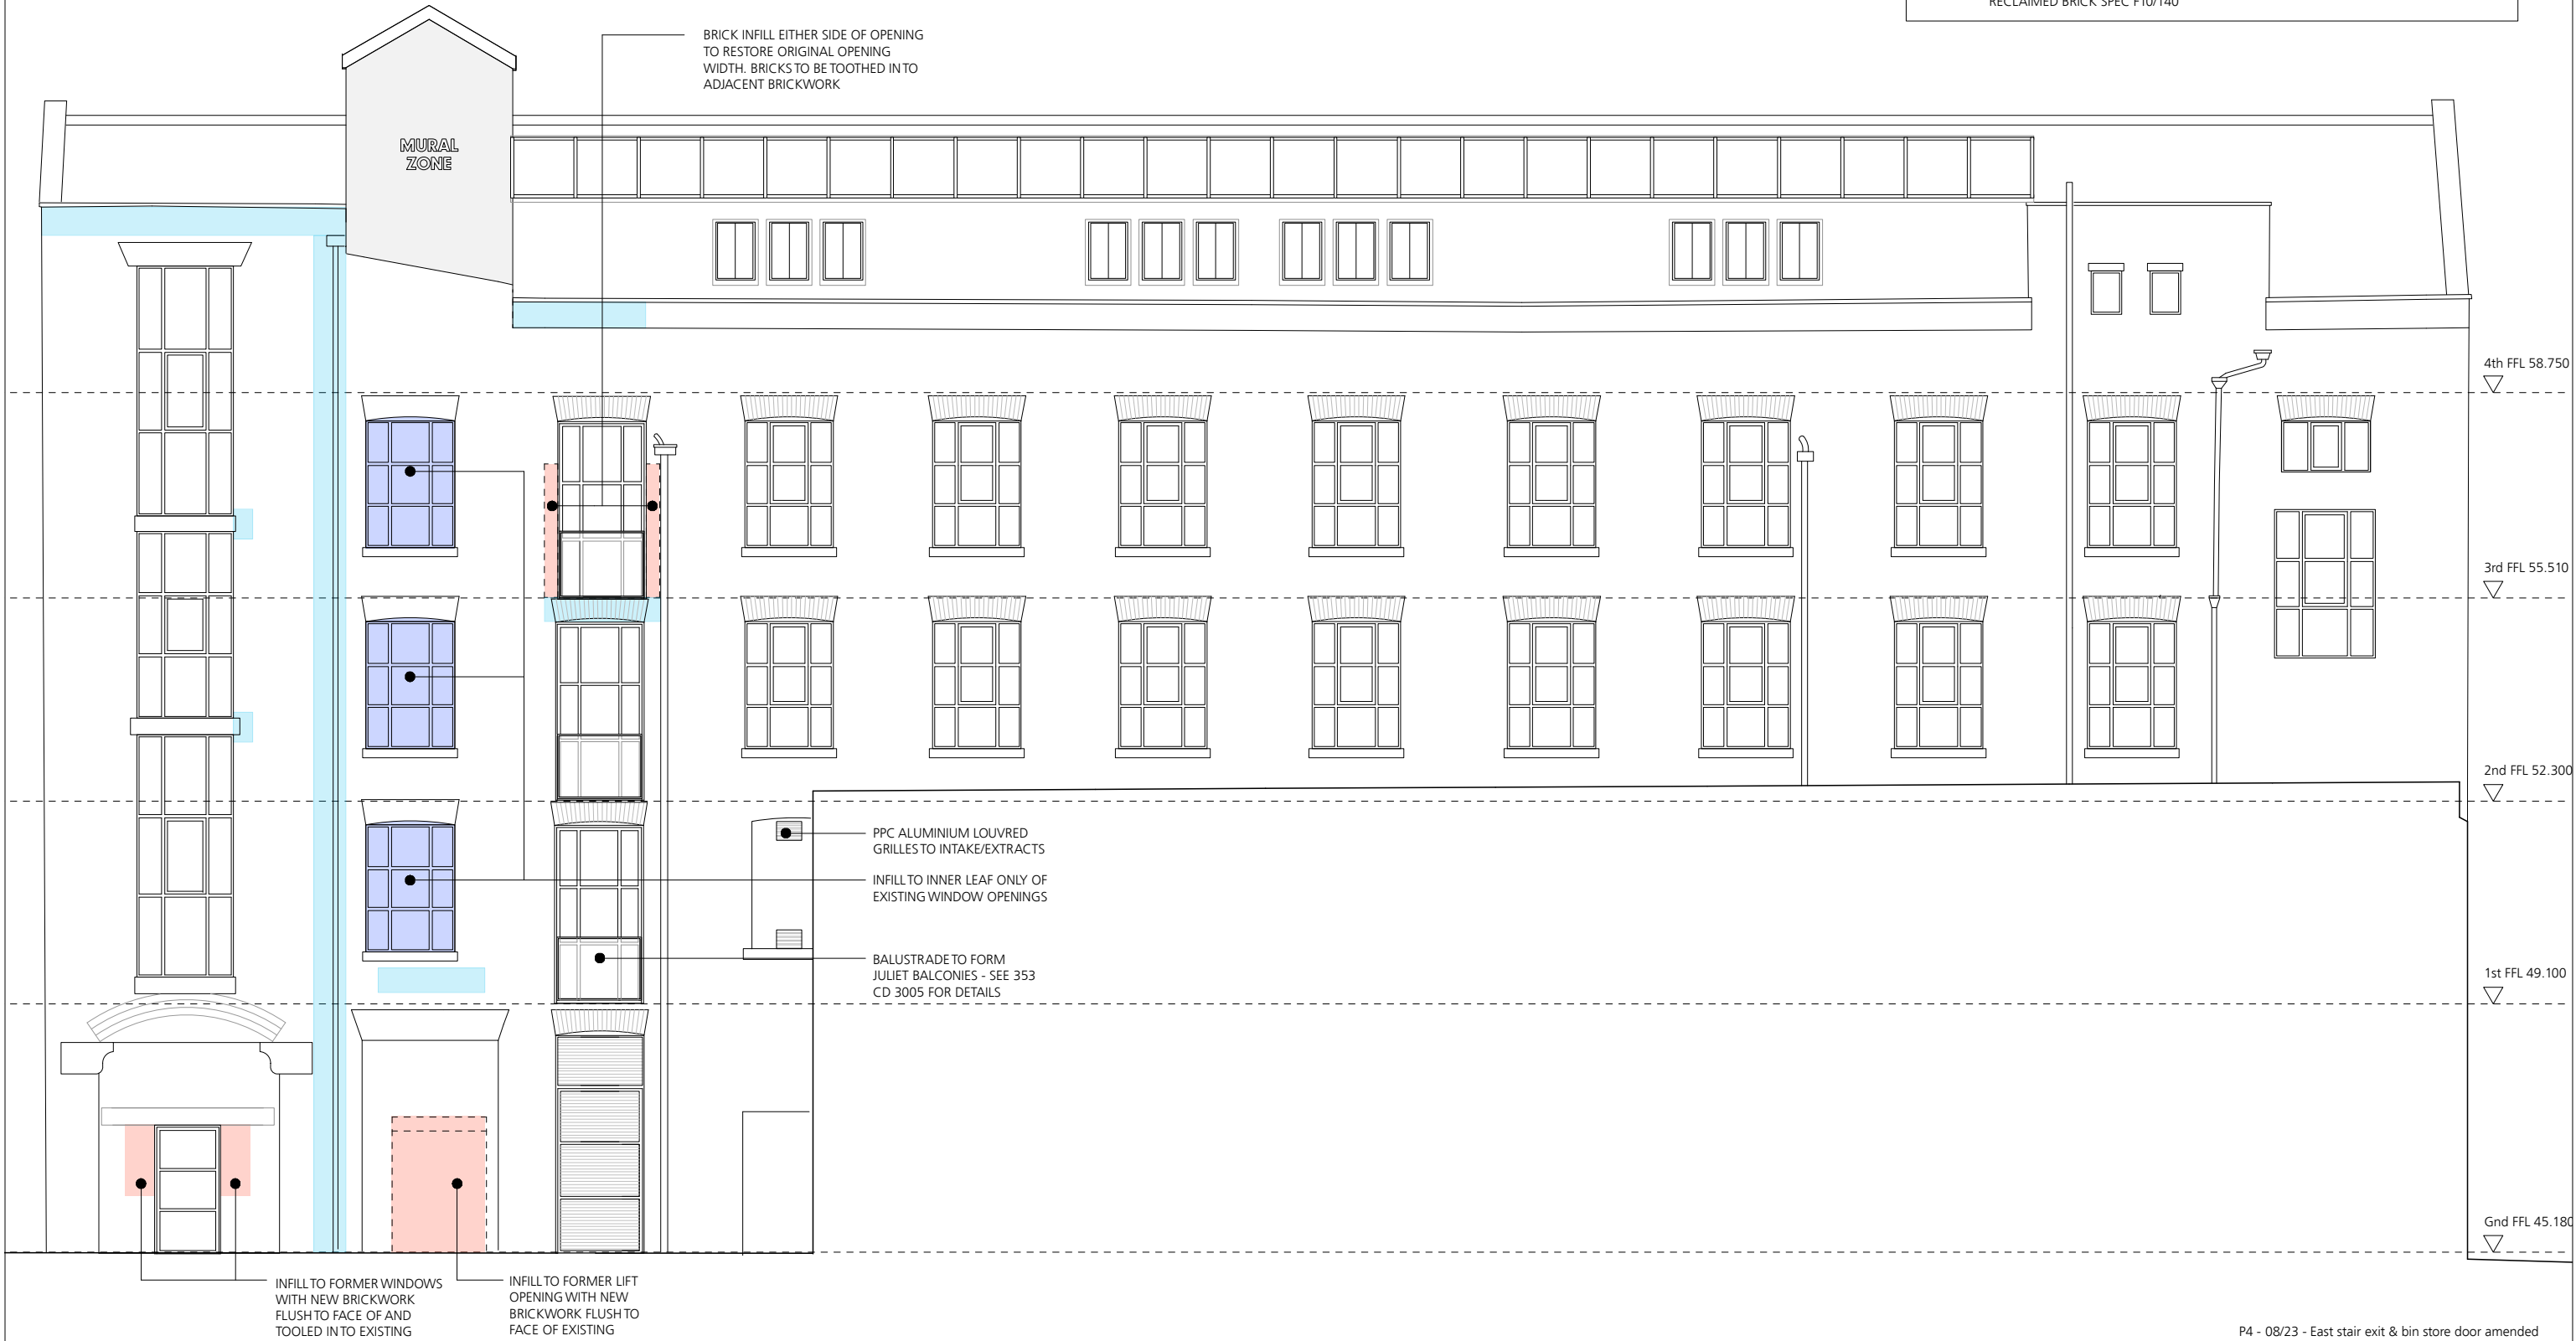
P4 - 08/23 - East stair exit & bin store door amended
P3 - 08/23 - Infill modified to lift shaft windows and ground floor doors, louvred cladding added at ground floor, mural zone reduced, juliet balconies noted, services louvres added
